**AGENDA
FARRAGUT MUNICIPAL PLANNING COMMISSION**

**March 21, 2019
7:00 p.m. Farragut Town Hall**

Site Layout Plan - South

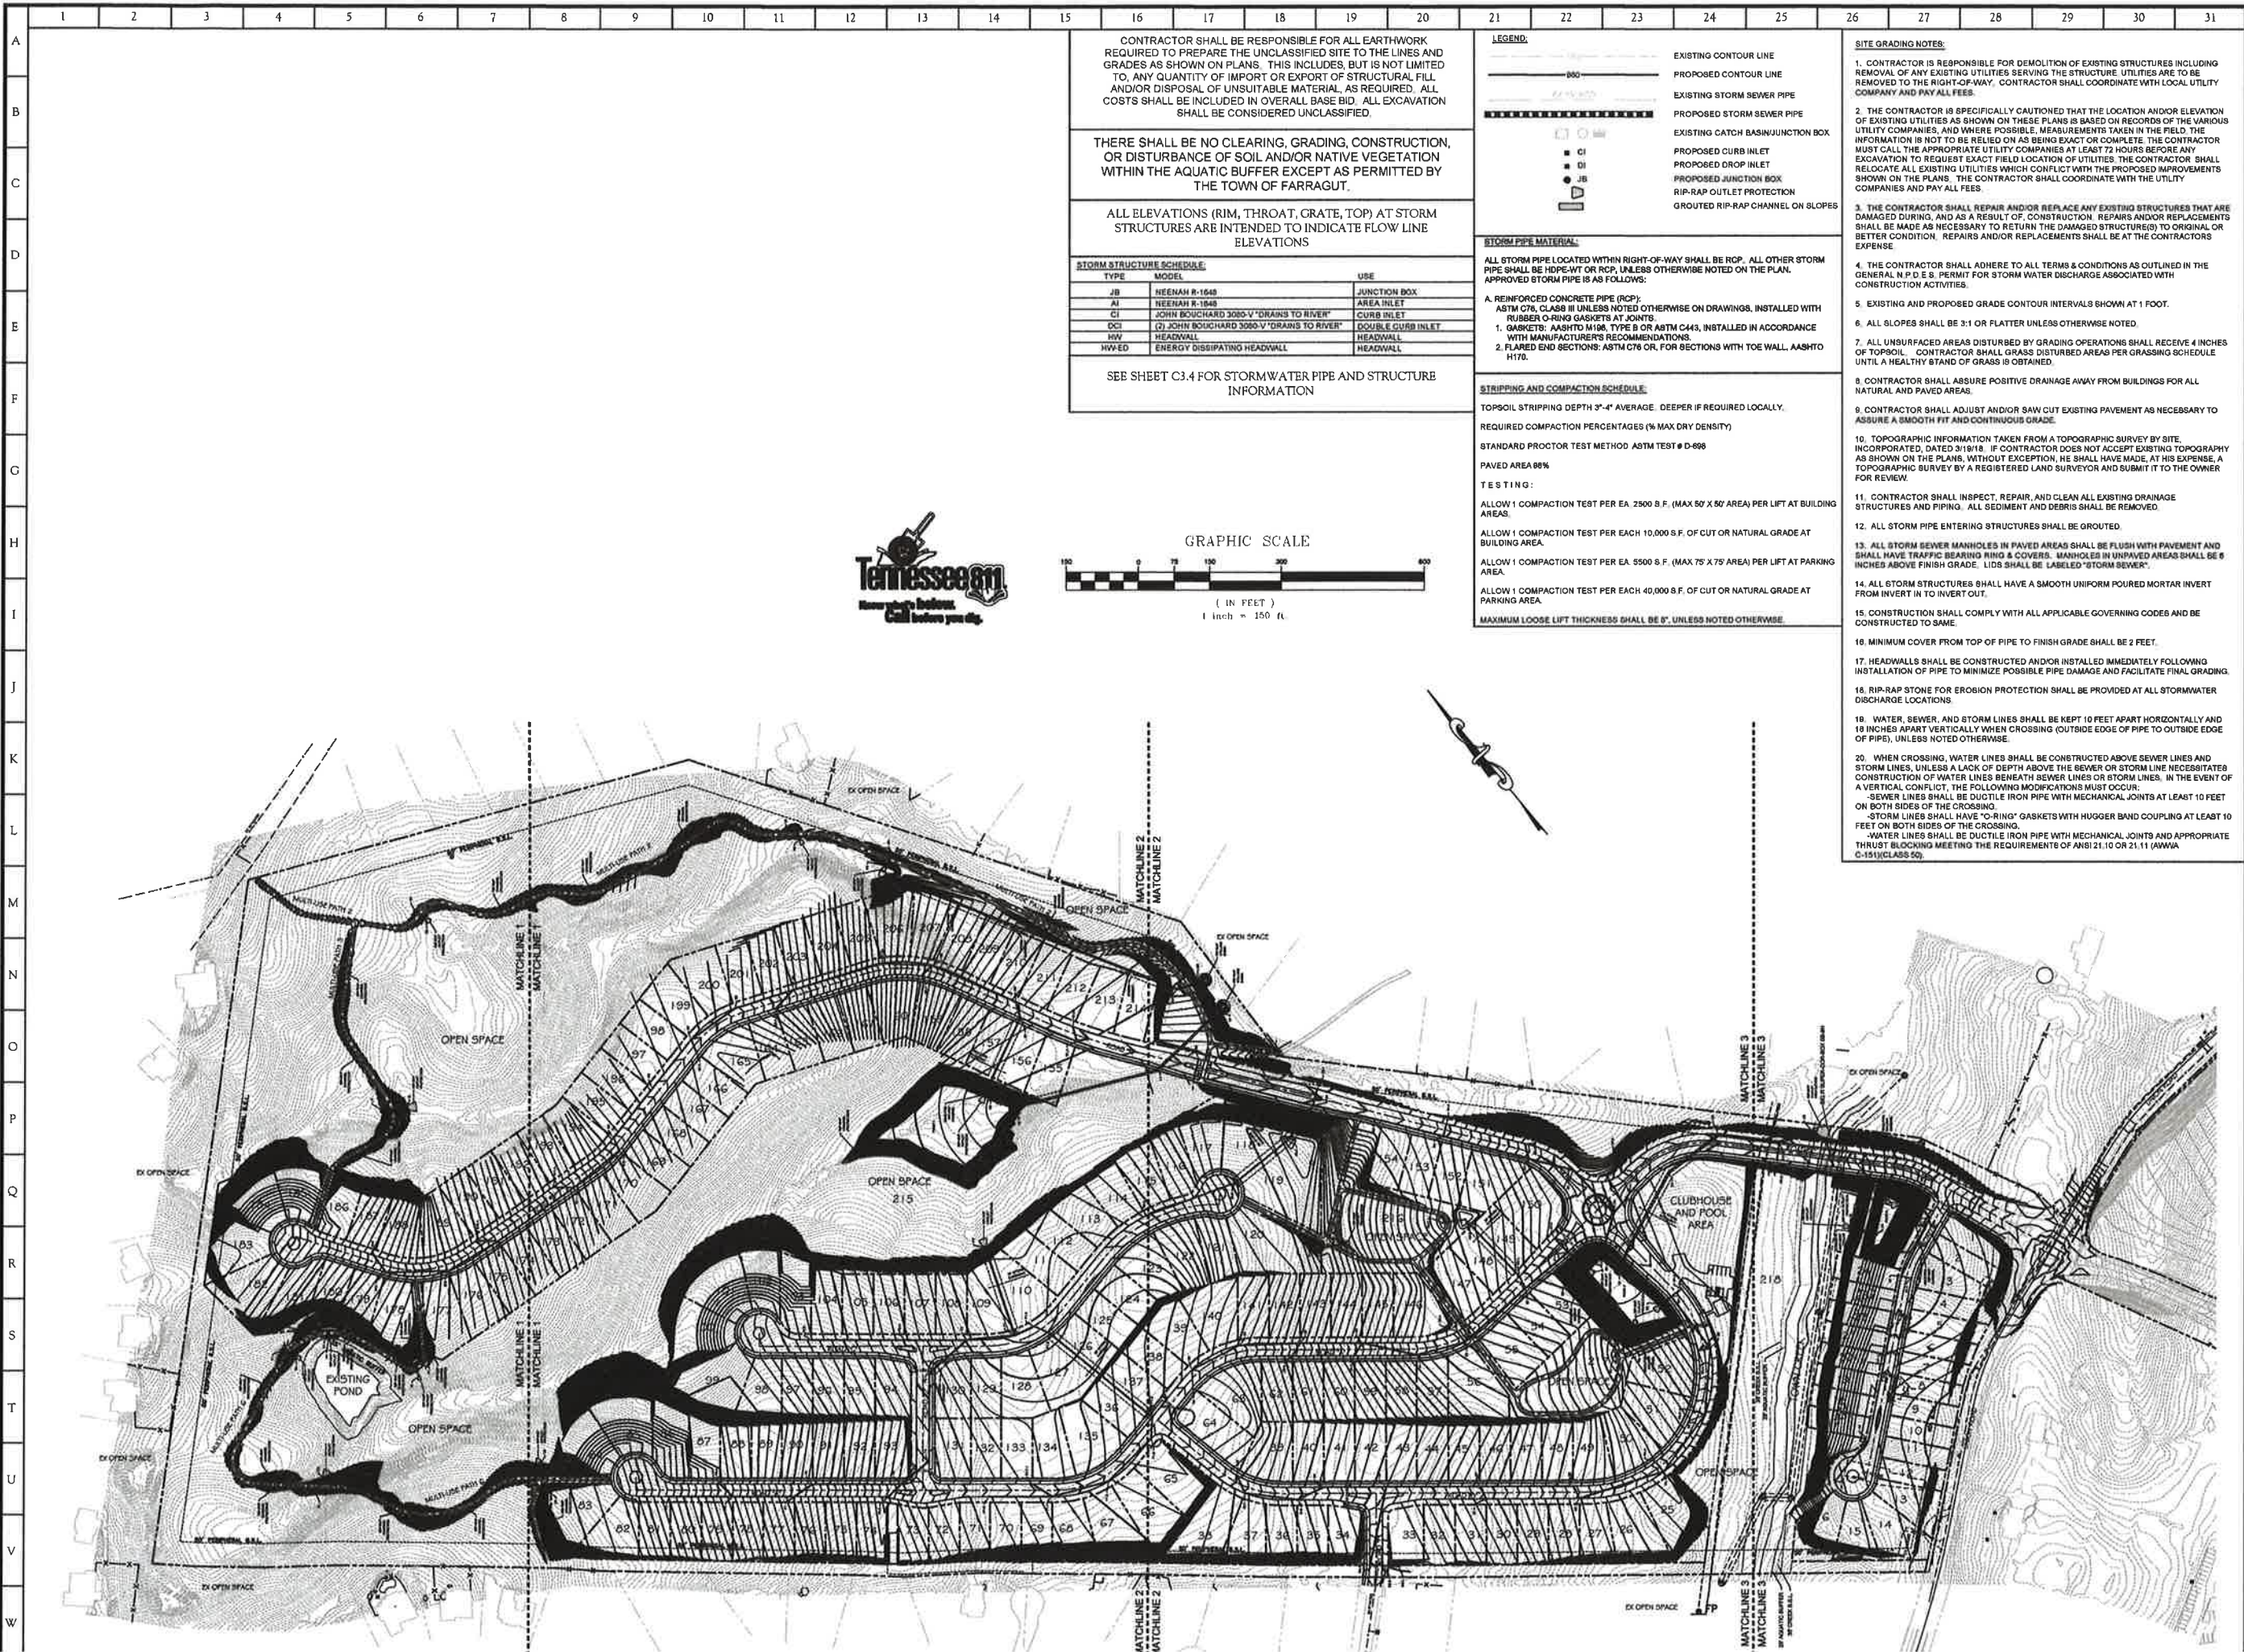
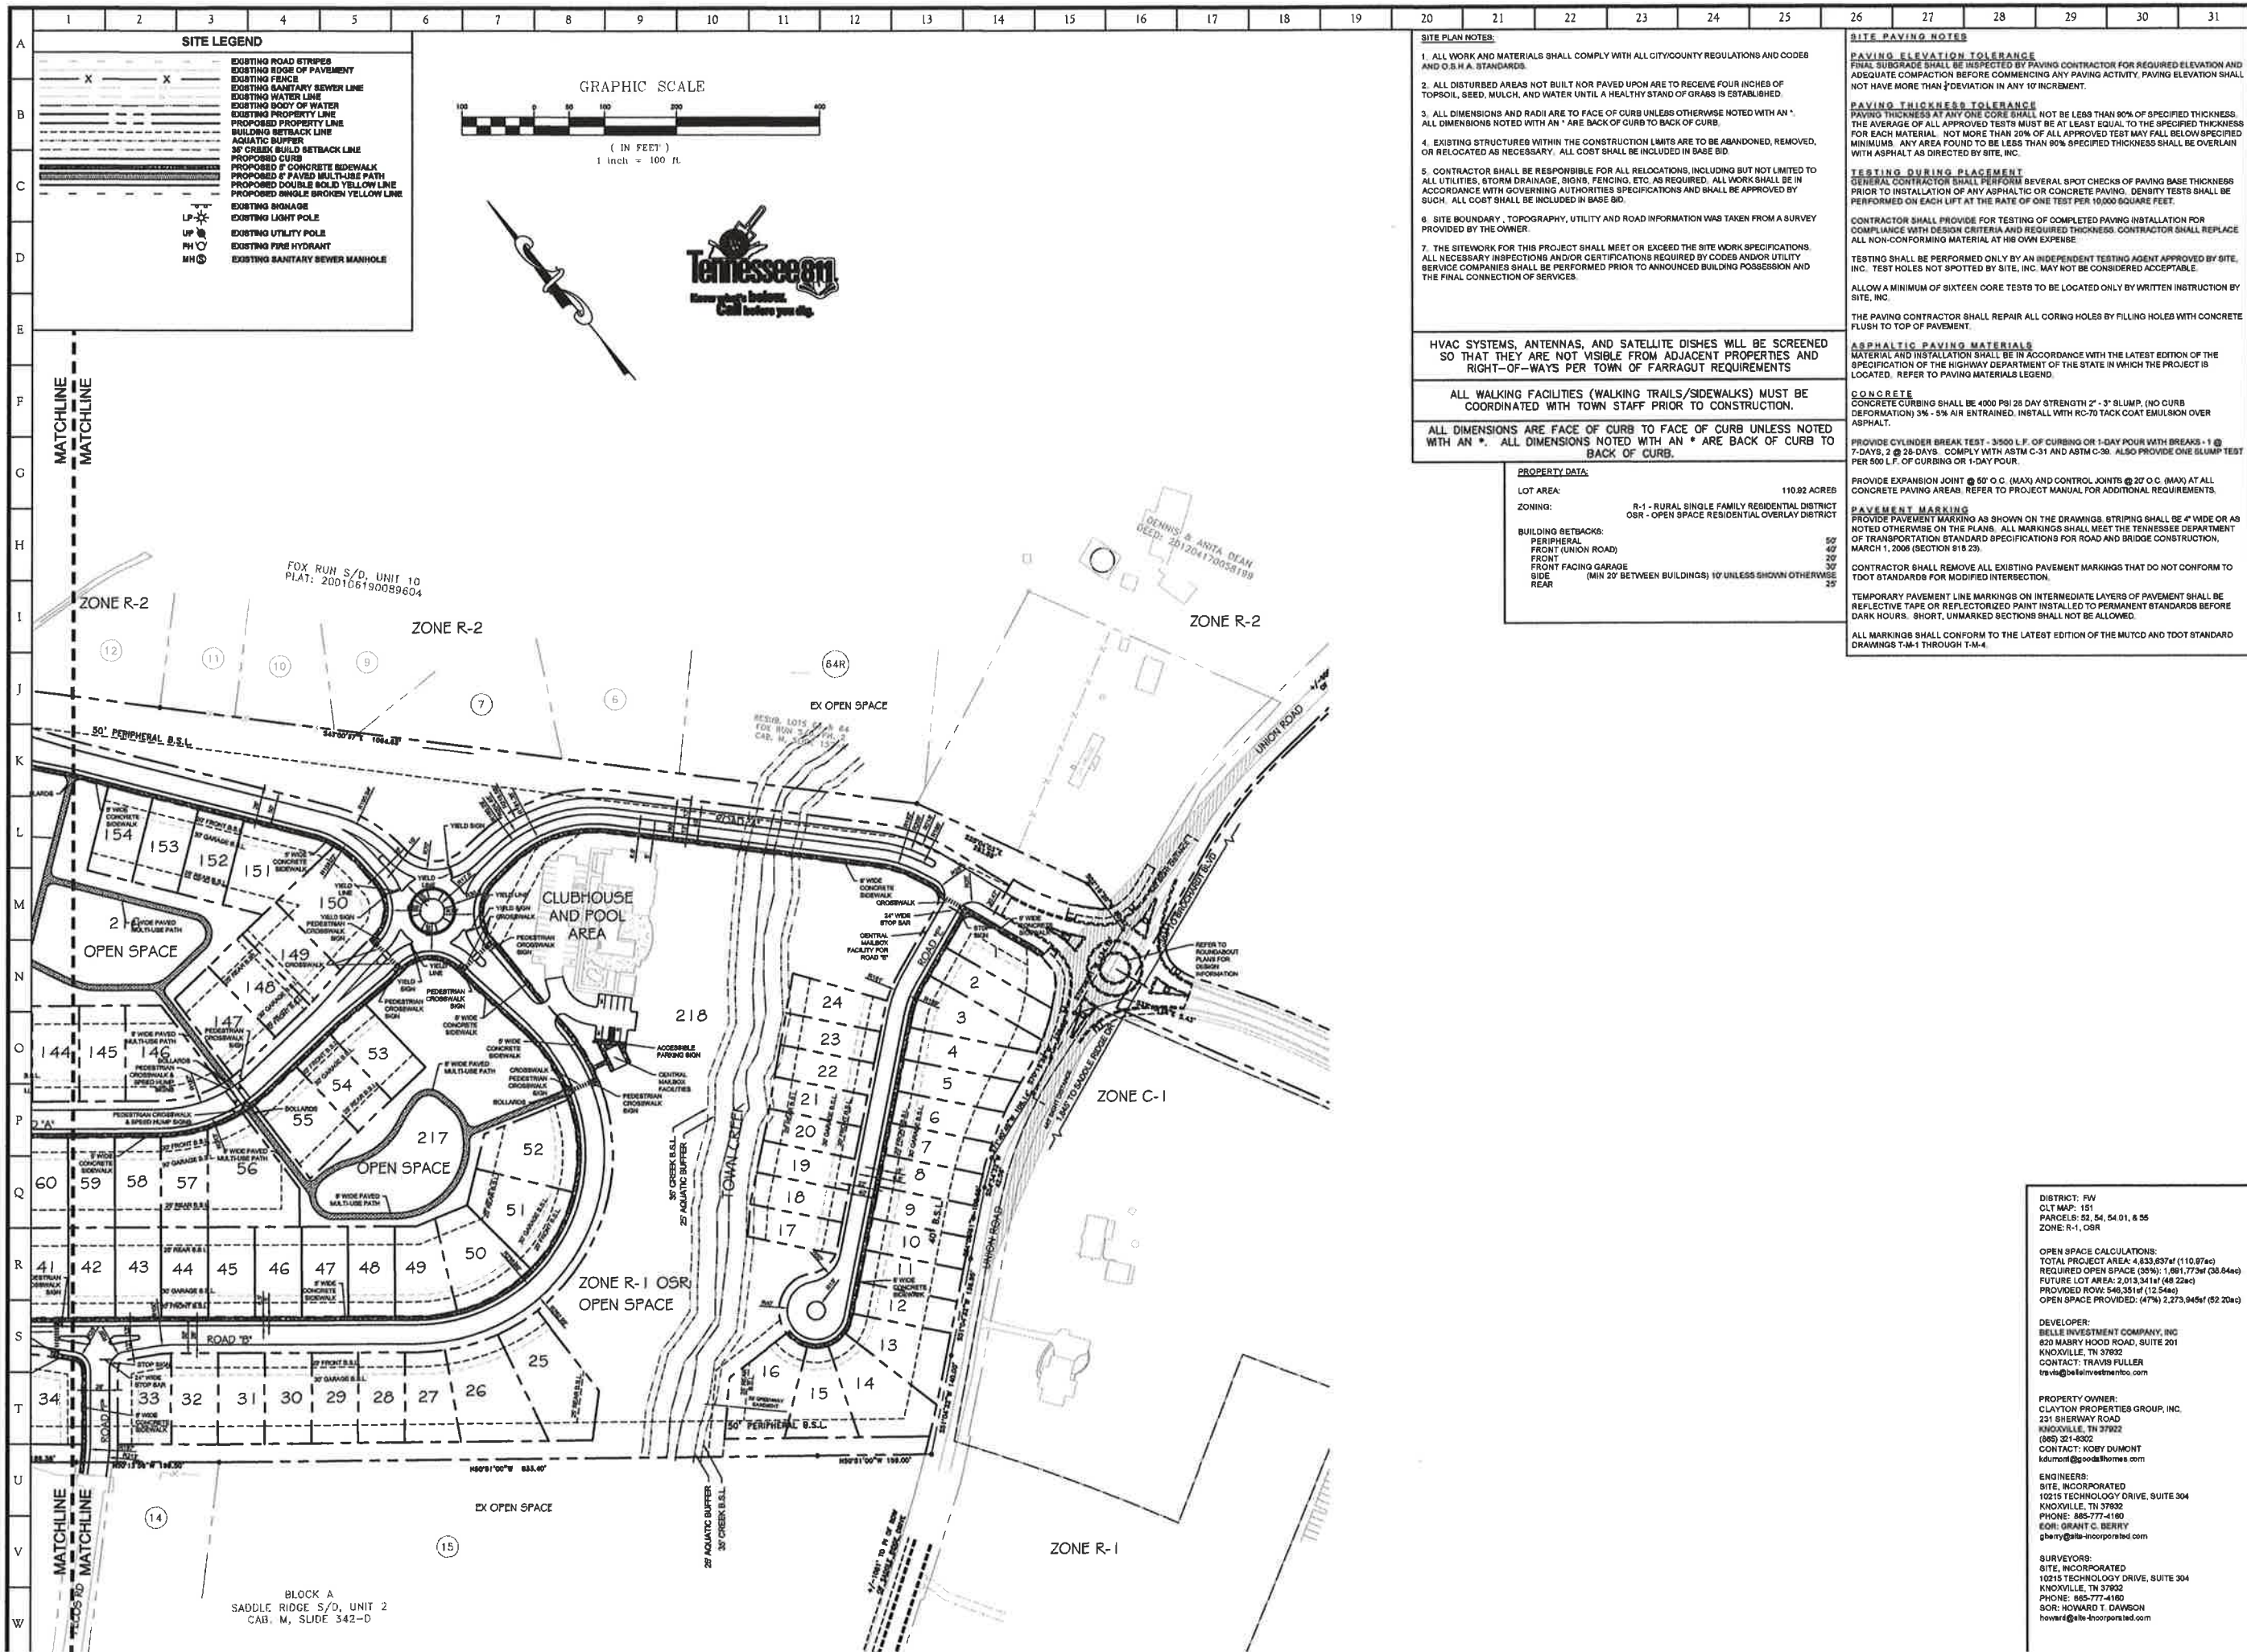
Response: Noted.
- 4) All utilities must be approved by the respective owner prior to approval of final plat;
Response: Noted.
- 5) Previous submittal showed path at approximately 20% grade at 10+00 to 12+50. This submittal has improved that grade only slightly (to about 18%). Can the path be relocated to provide a better grade?"

- 14) While we recognize that the grading plan shows the lots along Road E being filled, we still need to evaluate the finished floor elevation issue. This would include any potentially finished basement space. Elevation above the top of the stream bank is not the same as the elevation of potential flooding;

Response: Section of trail has been reduced to 15% from the allowable 20%.
- 6) Please provide detail drawings for Big R Super-Cor Box SB-9H (steel plate arch) over Town Creek on the detail sheets on the preliminary plat;

Response: Road E has an average road elevation of 935 that will puts the basement of lots 17-24 at approximately 927. The top of bank of the creek is at 917 giving 10ft of elevation between the basements and the creek. Stormwater would crest Road A, that is at an elevation of 924, before any potential flooding would occur.
